# Responses to CEC Data Requests Set One (60-Day Extension)

Amended Application for Certification  
for  
**HYDROGEN ENERGY CALIFORNIA**  
(08-AFC-8A)  
Kern County, California

**October 2012**

**RESPONSES TO DATA REQUESTS SET 1 (60-DAY EXTENSION)  
FROM CALIFORNIA ENERGY COMMISSION (CEC)**

**FIGURE A93-1**

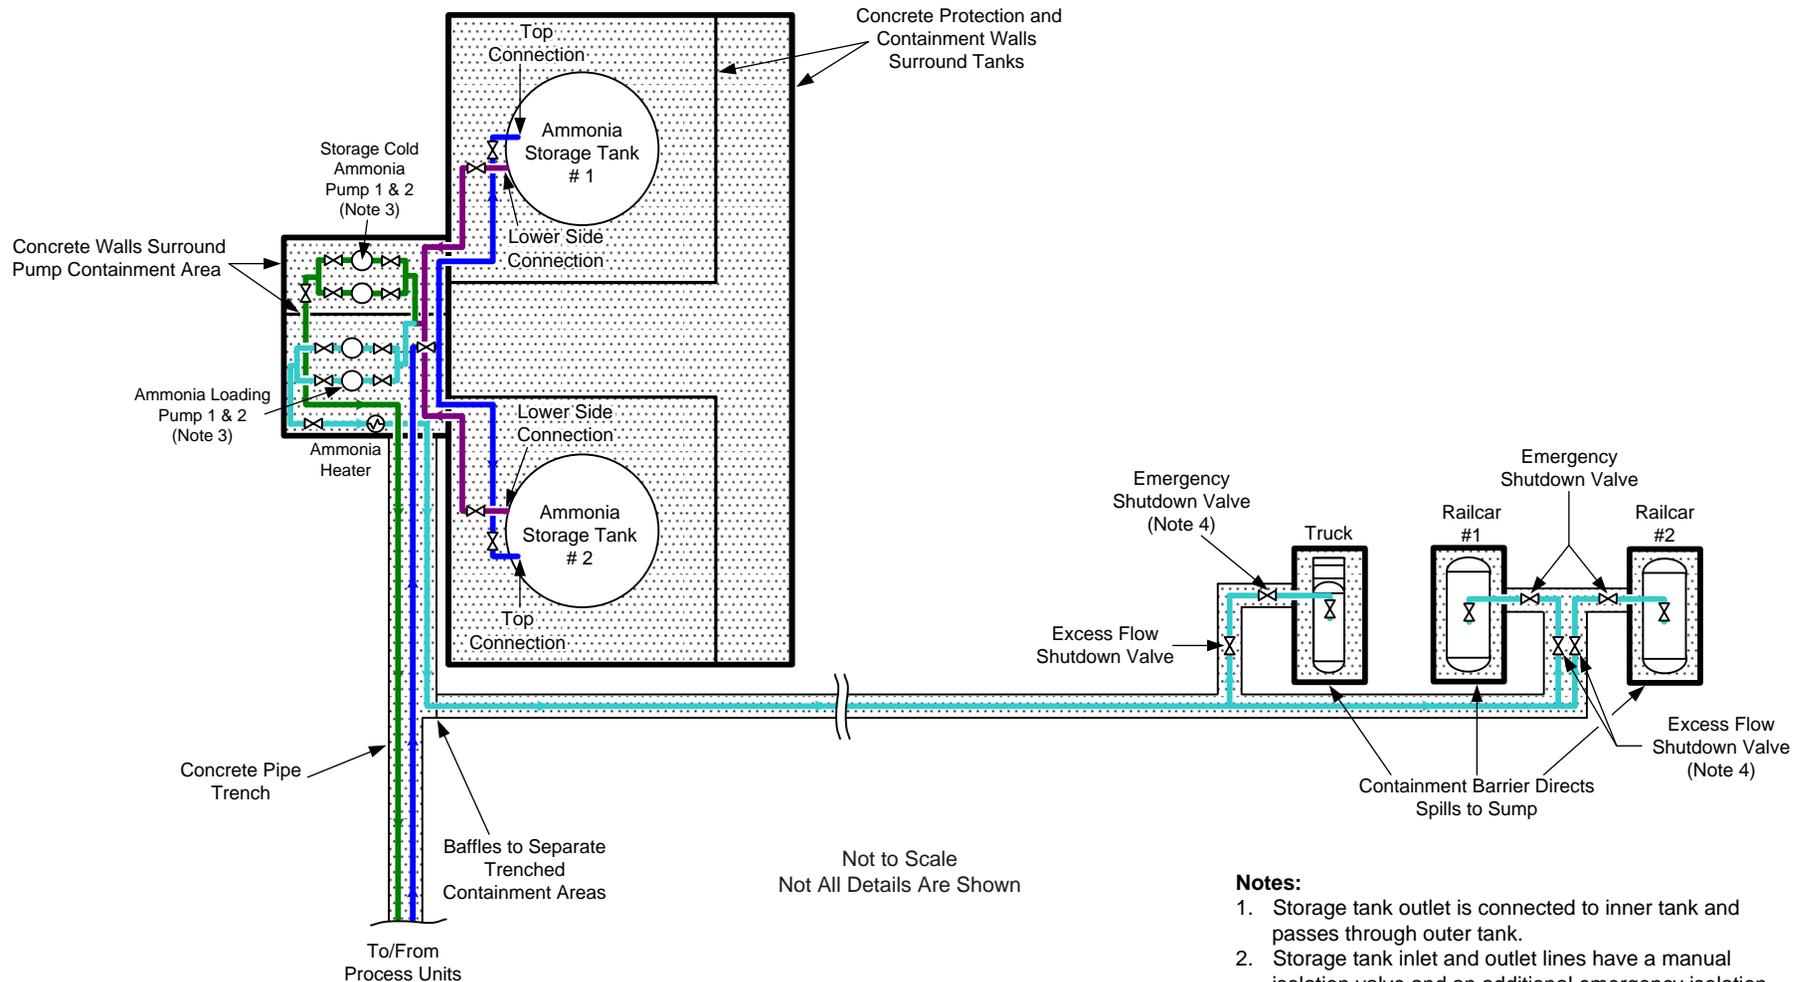
**A97. Please provide a schematic diagram of the anhydrous ammonia transfer facility showing the piping and valves through which anhydrous ammonia will flow out of the storage tanks, secondary containment should a spill occur during transfer operations, the location, type, and detection limits of ammonia sensors, and conduct an OCA of the worst-case accidental release during transfer to tanker trucks and rail cars.**

A schematic drawing showing the piping and valves through which anhydrous ammonia will flow into and out of the storage tanks is provided as Figure A93-1.

See Figure A93-1 in the response to Data Request A93 for the schematic drawing of the anhydrous ammonia transfer facility showing the piping and valves through which anhydrous ammonia will flow out of the storage tanks and the secondary containment should a spill occur during transfer operations. The response to Data Request A93 also provides a description of the ammonia storage tank and transfer pipe protection systems.
